ADDENDUM NO. 2 TO PROJECT NO. 47552

ELECTRICAL WORK UPGRADE ELECTRONIC SECURITY SYSTEMS VALLEY RIDGE CIT 274 CHIARINO DRIVE NORWICH NY 13815

November 20, 2024

PROJECT NUMBER:	47552 - E	
DESIGNED BY:	MJP	
DRAWN BY:	MJP	
FIELD CHECK:		
APPROVED:	NCH	
SHEET TITLE:	PROGRAM BUILDING CLOSET 11 SECURITY SYSTEMS RACK ELEVATION STEP-2	
DRAWING NUMBER:	E-734

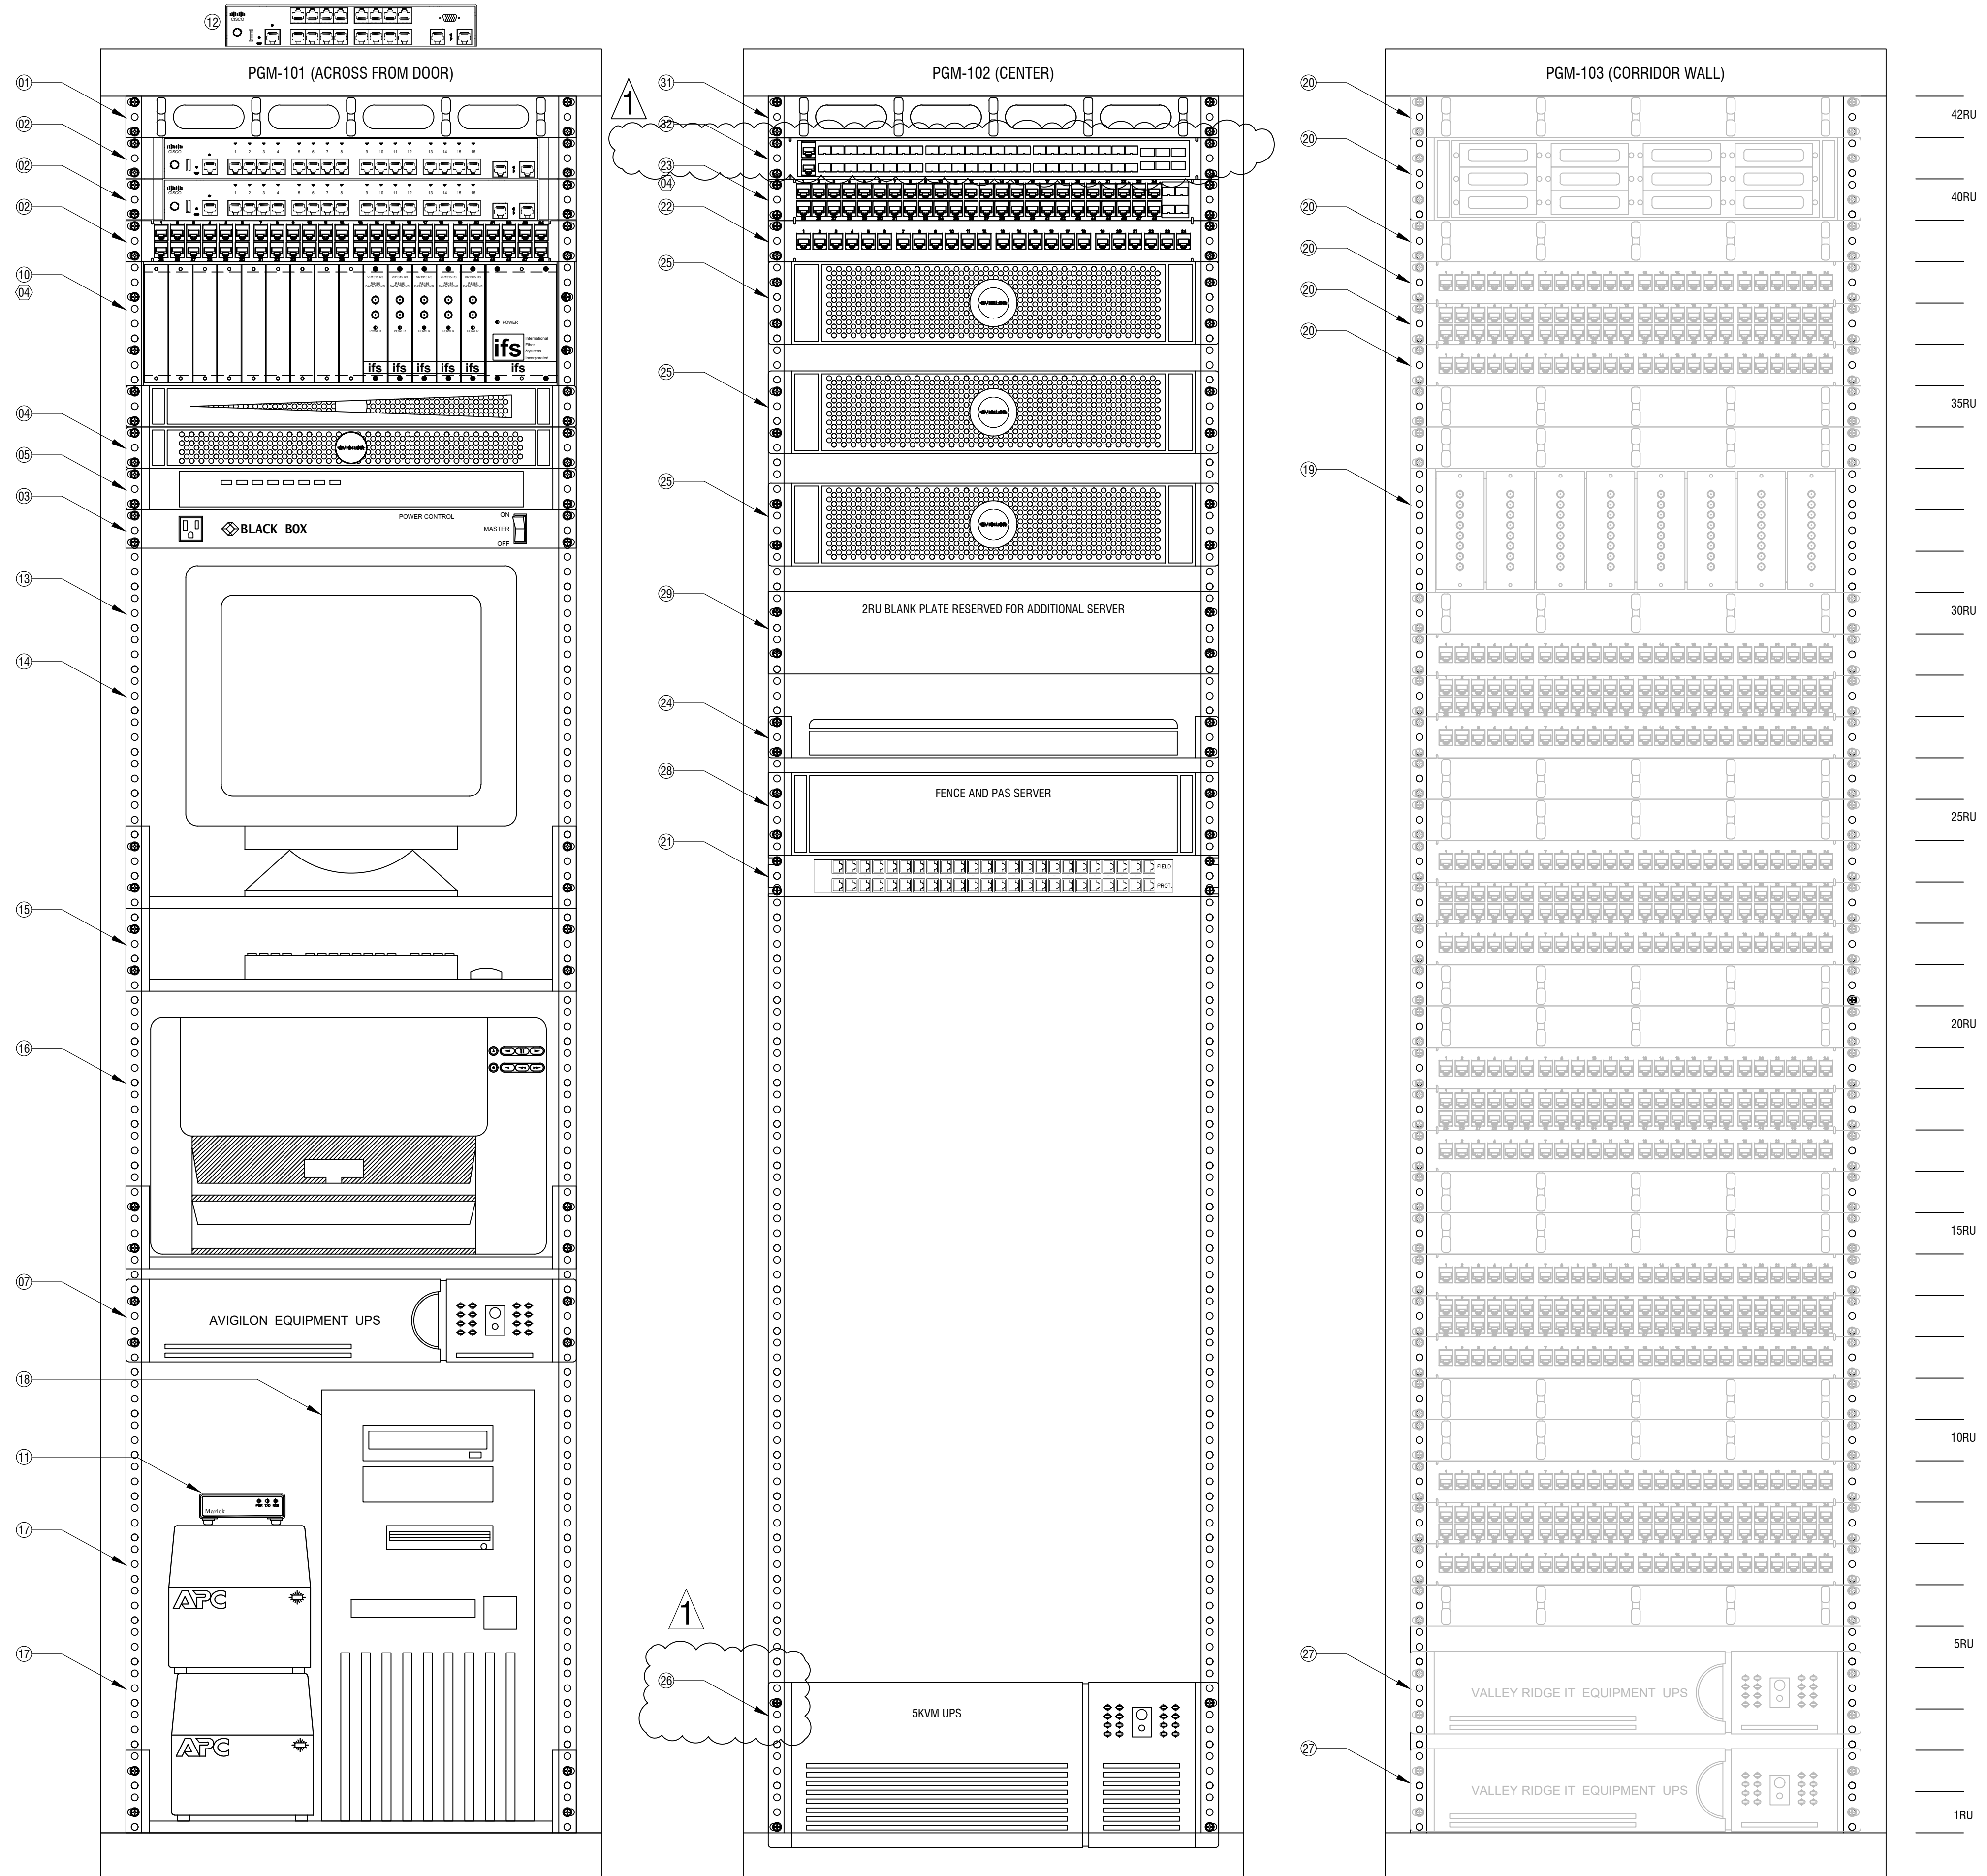
- 19) EXISTING SITE OFTR
- 20) EXISTING EQUIPMENT TO REMAIN/DISREGARD (TYP IN RACK)
- 21) PROVIDE 24 SURGE PROTECTOR, CCTV, PAS
- 22) PROVIDE 24 PORT PATCH PANEL, ACS, CCTV, PAS

- 23) PROVIDE 48 PORT NETWORK SWITCH WITH 4 FIBER PORTS
- 24) PROVIDE 8-PORT KVM-SERVER MONITOR
- 25) PROVIDE AVIGILON VIDEO STORAGE SERVER
- 26) PROVIDE NEW SKVA UPS

- 27) PROVIDE POWER STRIP IN BACK OF RACK
- 28) PROVIDE SENSTAR AND CENTRAK SERVER
- 29) RESERVED SPACE LEAVE OPEN
- 30) PROVIDE SENSTAR NETWORK INTERFACE UNIT (NIU)

- 31) PROVIDE 1RU CABLE MANAGEMENT WITH "FEED THROUGH"
- 32) PROVIDE 1RU 48 PORT SWITCH WITH 6-SFP PORTS

- 01) REMOVE EQUIPMENT AND TURN OVER TO CUSTOMER
- 02) RELOCATE EQUIPMENT TO BACK OF RACK 1
- 03) RELOCATE EQUIPMENT TO RACK 2 REFER TO DWG E-729
- 04) PROVIDE JFOS TO RACK 3

PROJECT NUMBER:	47552 - E
DESIGNED BY:	MJP
DRAWN BY:	MJP
FIELD CHECK:	
APPROVED:	NCH
SHEET TITLE:	PROGRAM BUILDING CLOSET 11 SECURITY SYSTEMS RACK ELEVATION STEP-3
DRAWING NUMBER:	E-735

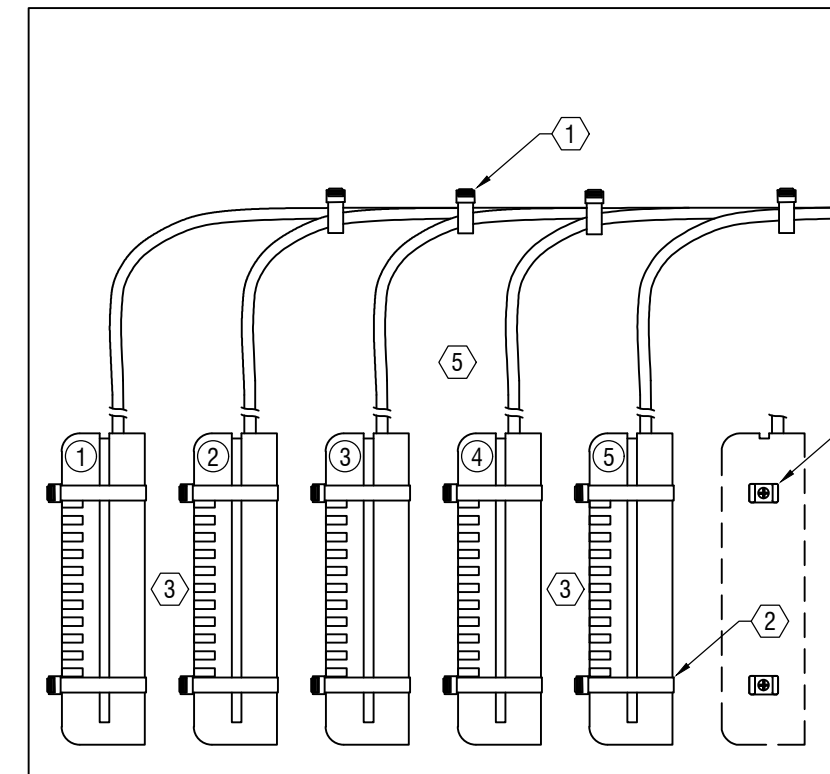
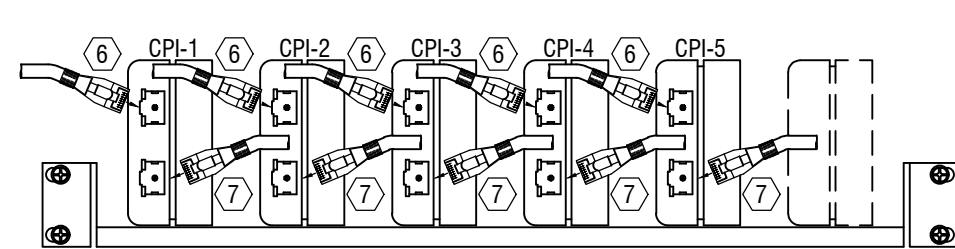
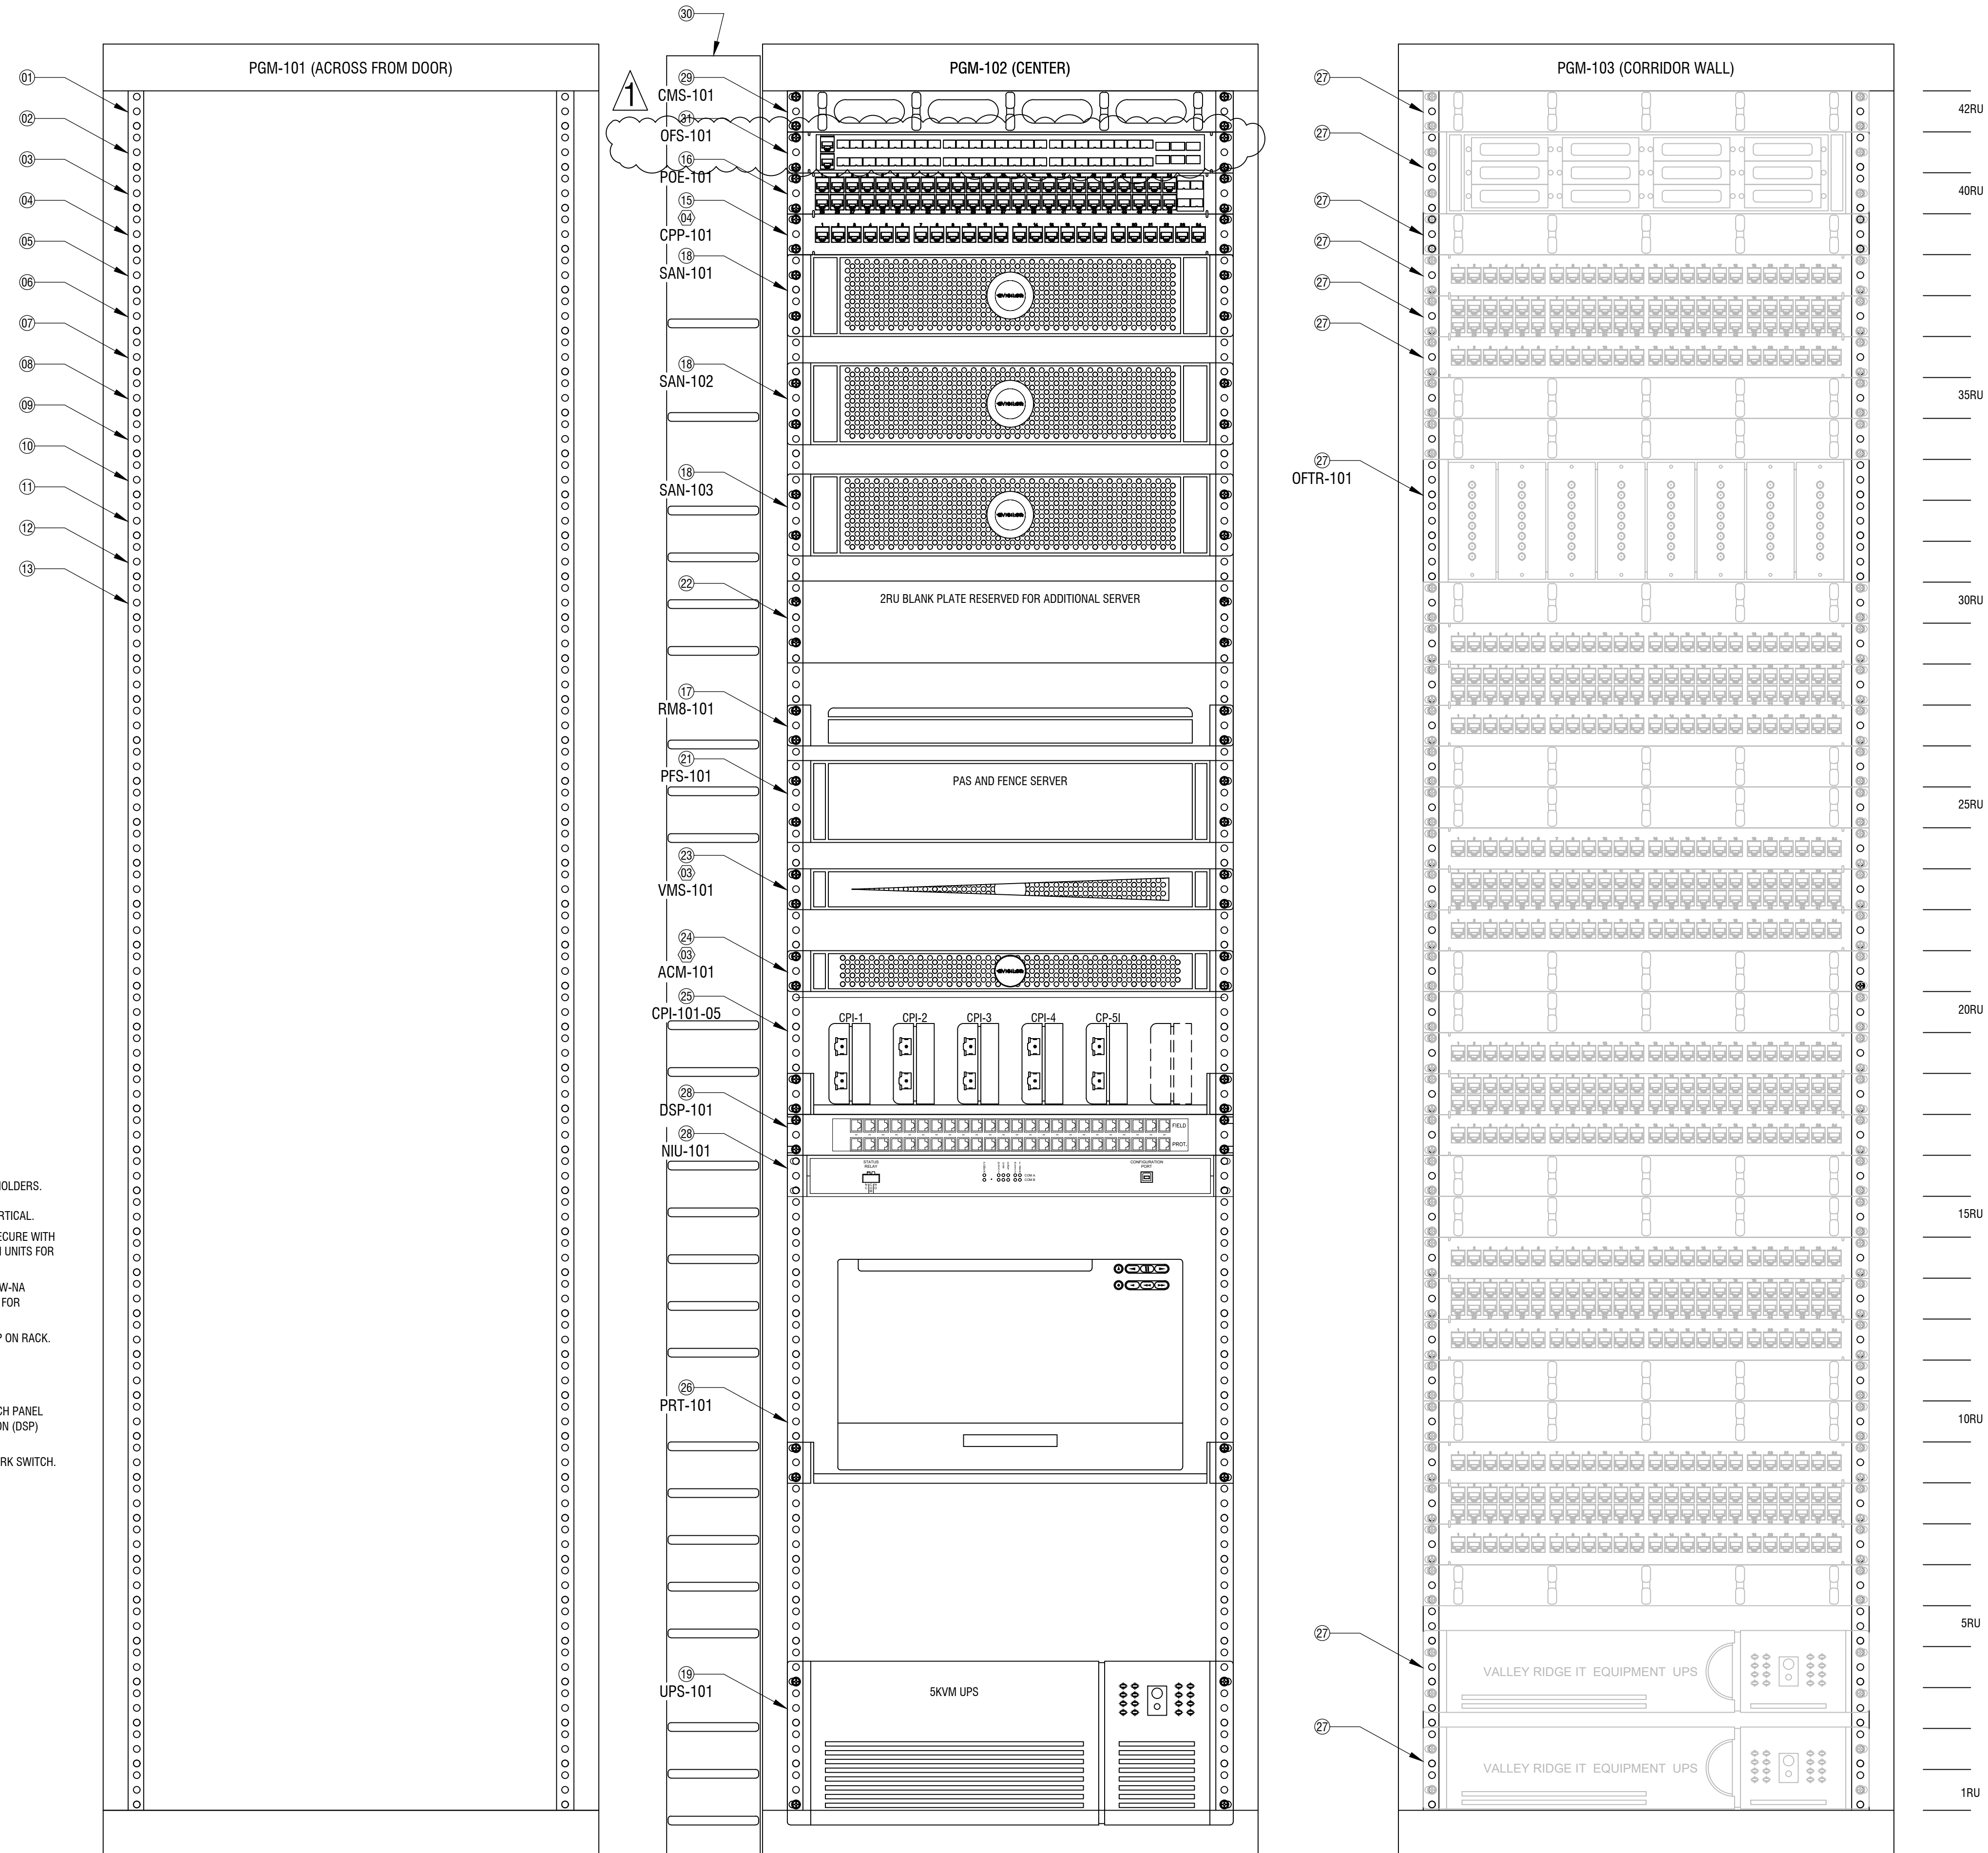
- 14 PROVIDE 24 SURGE PROTECTOR, CCTV, PAS
- 15 PROVIDE 24 PORT PATCH PANEL, ACS, PAS, CCTV
- 16 PROVIDE NETWORK SWITCH WITH FIBER PORTS
- 17 PROVIDE 8-PORT KVM-SERVER MONITOR
- 18 PROVIDE AVIGILON VIDEO STORAGE SERVER
- 19 PROVIDE UPS
- 20 PROVIDE POWER STRIP IN BACK OF RACK
- 21 PROVIDE SENSTAR AND CENTRAK SERVER
- 22 RESERVED SPACE LEAVE OPEN
- 23 EXISTING AVIGILON VIDEO SERVER
- 24 EXISTING AVIGILON ACCESS CONTROL MANAGER SERVER
- 25 PROVIDE SHELF WITH 90W POWER INJECTORS
- 26 PROVIDE NETWORK LASER REPORT PRINTER
- 27 EXISTING EQUIPMENT TO REMAIN/DISREGARD (TYP IN RACK)
- 28 PROVIDE SENSTAR NETWORK INTERFACE UNIT (NIU)
- 29 PROVIDE 1RU CABLE MANAGEMENT WITH "FEED THROUGH"
- 30 PROVIDE VERTICAL CABLE MANAGEMENT WITH "FEED THROUGH"
- 31 PROVIDE 1RU 48 PORT SWITCH WITH 6-SFP PORTS

- 01 REMOVE EQUIPMENT AND TURN OVER TO CUSTOMER
- 02 RELOCATE EQUIPMENT TO BACK OF RACK 1
- 03 RELOCATE EQUIPMENT FROM RACK 2 REFER TO DWG E-728
- 04 PROVIDE JFO'S TO RACK 3

- 1 PROVIDE SCREW DOWN TIE WRAP HOLDERS. SPACE APPROX. 3" HORIZONTAL AND 4" VERTICAL.
- 2 SIDE MOUNT UNIT ON SHELF AND SECURE WITH TIE WRAPS. LEAVE SPACE BETWEEN UNITS FOR VENTILATION.
- 3 PROVIDE CPI AVIGILON POE-INJ2-95W-NA POWER INJECTOR. RESERVE SPACE FOR 6TH FUTURE UNIT.
- 4 120VAC POWER TO UPS PLUG STRIP ON RACK.
- 5 19" X 16" MINIMUM 1RU SHELF.
- 6 LAN JUMPER CABLE TO CABLE PATCH PANEL (CPP) OR DEVICE SURGE PROTECTION (DSP) BEFORE CAMERA.
- 7 LAN JUMPER CABLE TO POE NETWORK SWITCH.
